419 71ST STREET
DPD #3017353

GREEN LAKE MIXED-USE

2ND EARLY DESIGN GUIDANCE MEETING

OCTOBER 27, 2014

VIEW FROM THE CORNER OF 5TH AVENUE NE & NE 71ST STREET

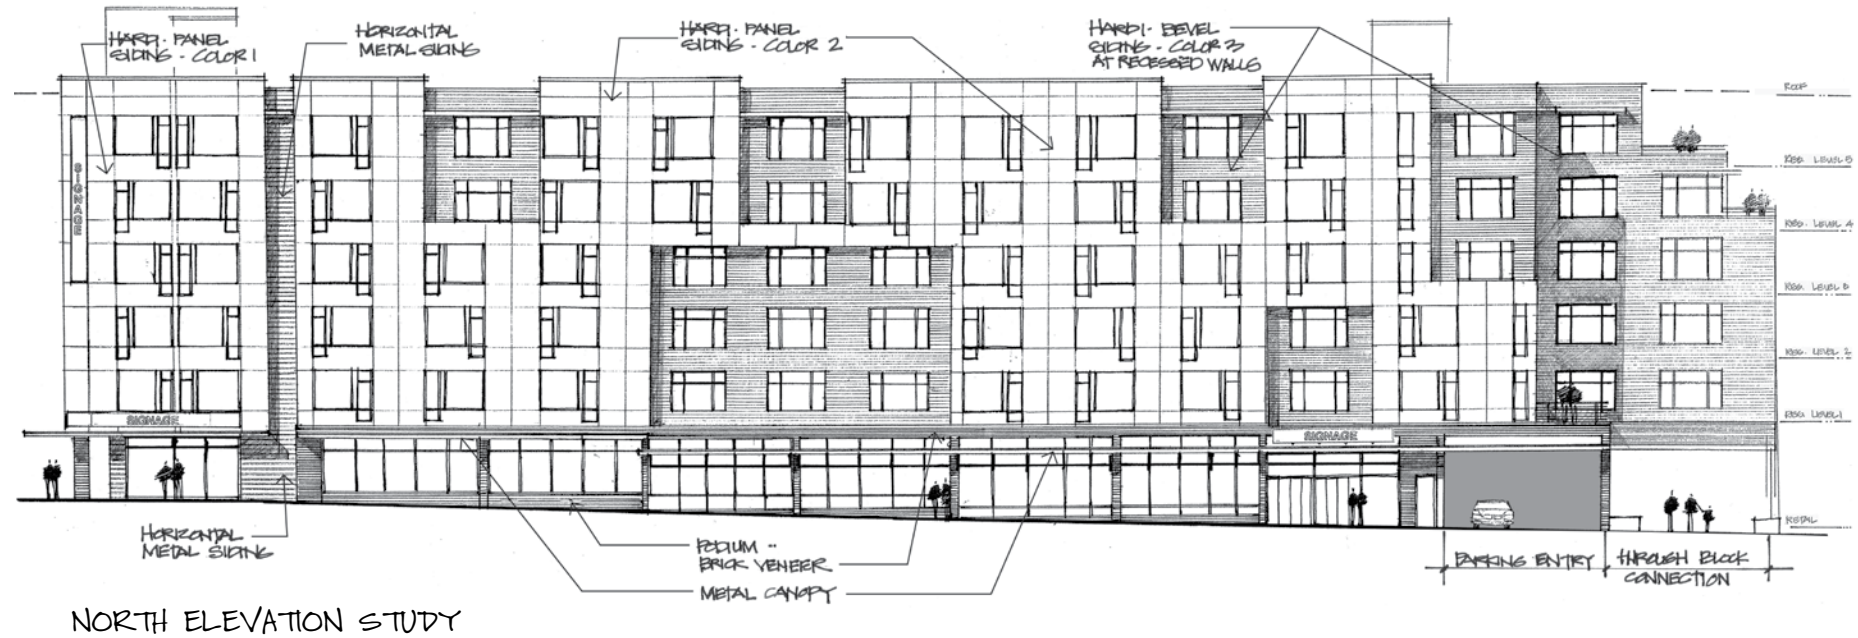
During the August 18, 2014 EDG, the Board provided the following specific comments on Applicant's use of material on exterior elevations:

The Board supported use of brick material at ground level. The Board felt a more durable, quality material should be explored at the upper levels to better meet the guidelines as part of the departure request for lot coverage above 13 feet. The Board encouraged use of durable, quality materials, respectful of the existing materiality context of the established Green Lake Neighborhood context (DC2-C3, DC4-A1, DC4-I).

Proponent intends to use metal siding, brick, aluminum storefront, steel canopies, smooth cementitious siding, lap siding, and metal bolt-on decks etc. The materials and colors will continue to be further explored and considered for the recommendation meeting.

RESIDENTIAL LEVEL TYPICAL

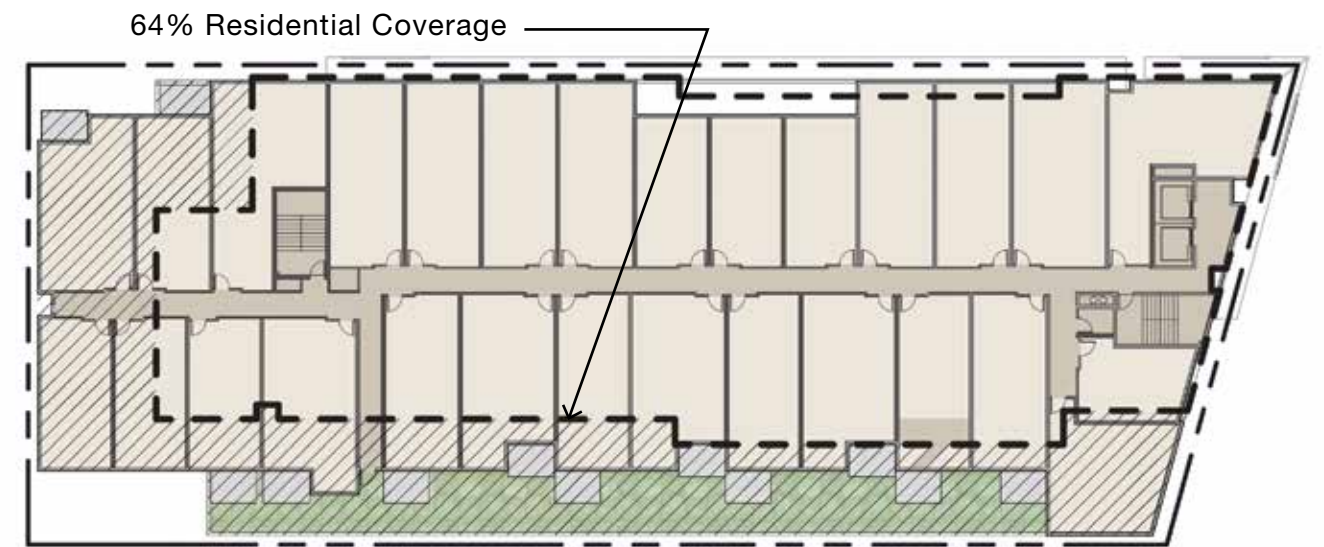
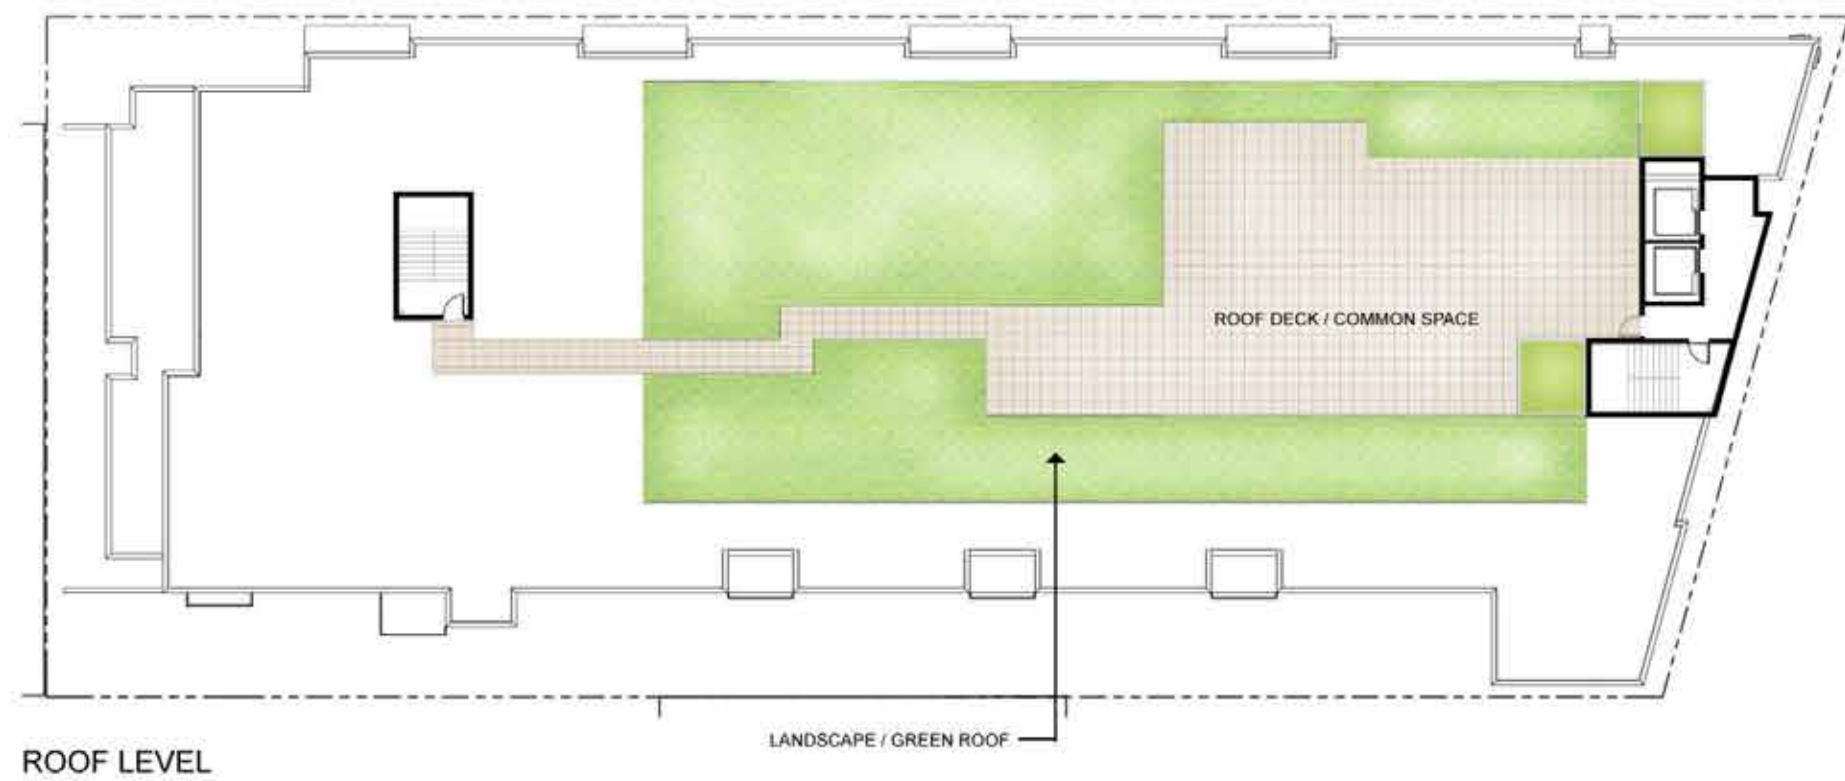
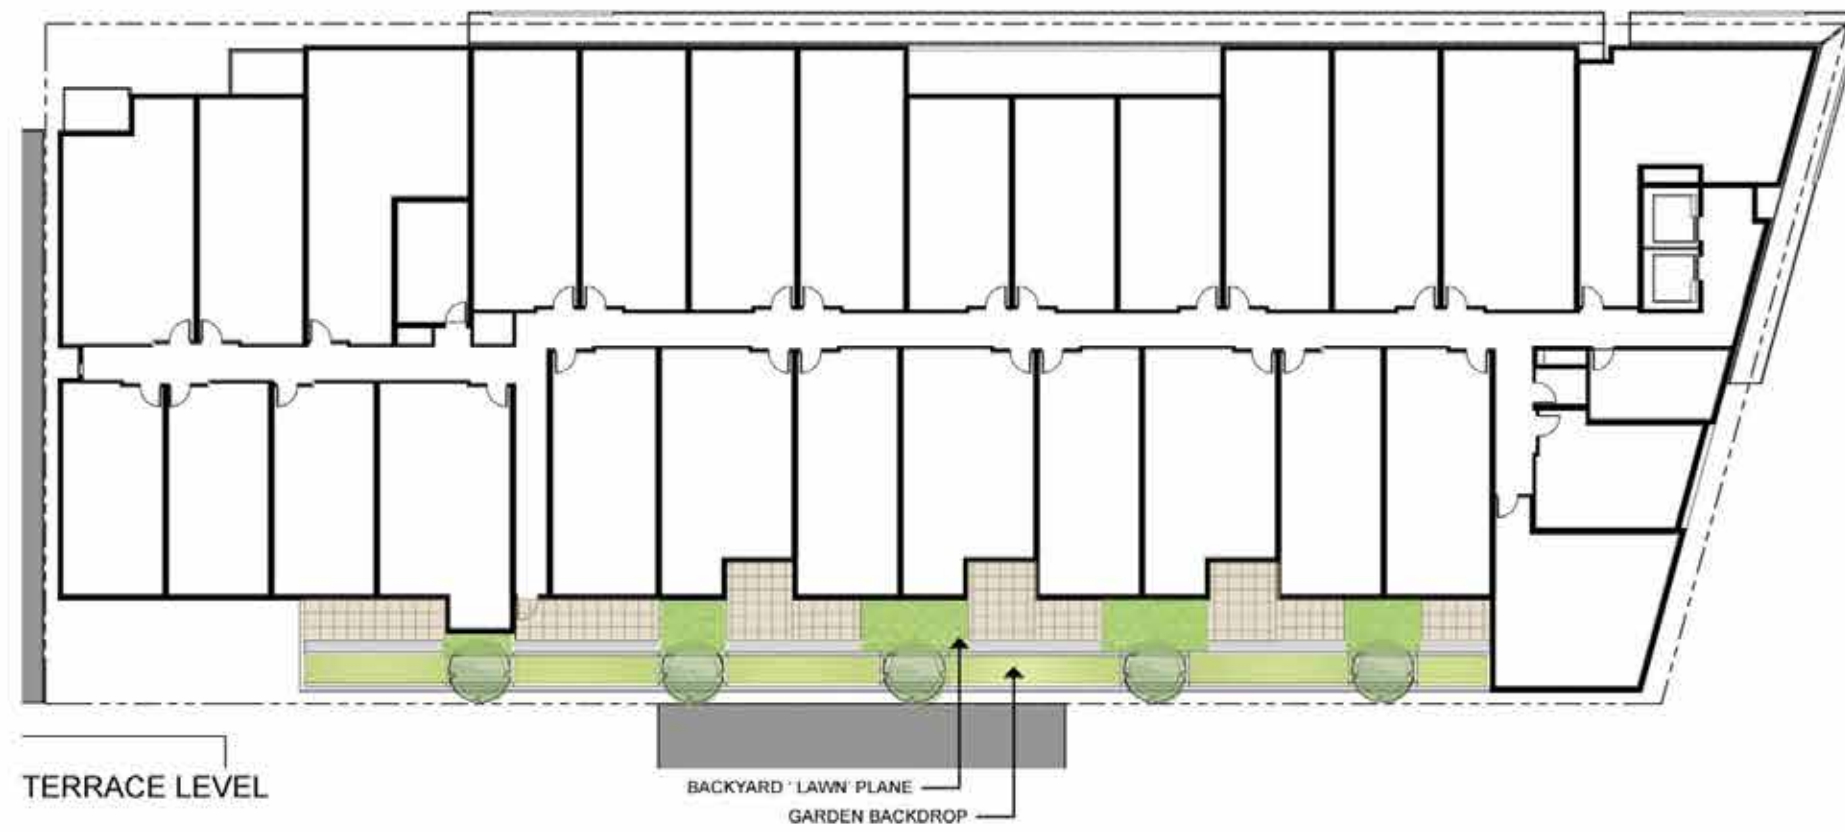
During the August 18, 2014 EDG, the Board provided the following specific comments on Design Departures Applicant requested:

“At the time of the Early Design Guidance Meeting the following departures were requested:

Lot Coverage above 13 Feet (Property Use and Development Agreement): The PUDA limits the lot coverage above 13 feet to 64%. Applicant proposes 78% lot coverage above 13 feet.

The Board felt additional massing studies were necessary before reviewing the requested departure. The Board agreed that the applicant must make a good faith effort at incorporating a through block connection, provide quality ground level amenity space, and provide quality materials at all levels of the building to substantiate the request for departure in upper level lot coverage consistent with Design Guidelines DC2 Architectural Concept, DC3 B and C Open Space Uses and Activities and Design, and DC4-A Exterior Finish Materials.”

As requested by the Board, all current options have incorporated a through-block connection. This connection space, as shown in the landscape sketches on the through-block sheet, is being designed as a ground level amenity space.

Applicant requests that the Board grant a departure from the 64% residential lot coverage requirement set forth in this section to allow for residential lot coverage of 78% above 13 feet. In 2007, the Board recommended approval of the same departure for Green Lake Village. The present project is designed to complement and reinforce the Green Lake Village project by providing comparable levels of high-quality residential density, additional commercial uses, and complementary design that shapes an active, contiguous pedestrian corridor leading to the lake. The project includes significant street-level landscaping and pedestrian amenities with upper-level massing that creates an attractive urban edge as envisioned by both the Green Lake Neighborhood and city-wide Design Guidelines. If strictly applied, the 64% residential lot coverage requirement will dramatically reduce the project’s density with no corresponding benefit. Such a reduction is also counter to the City’s Green Lake neighborhood planning efforts to encourage density and urban design at this location. (See also remarks on PUDA Exhibit 12.)
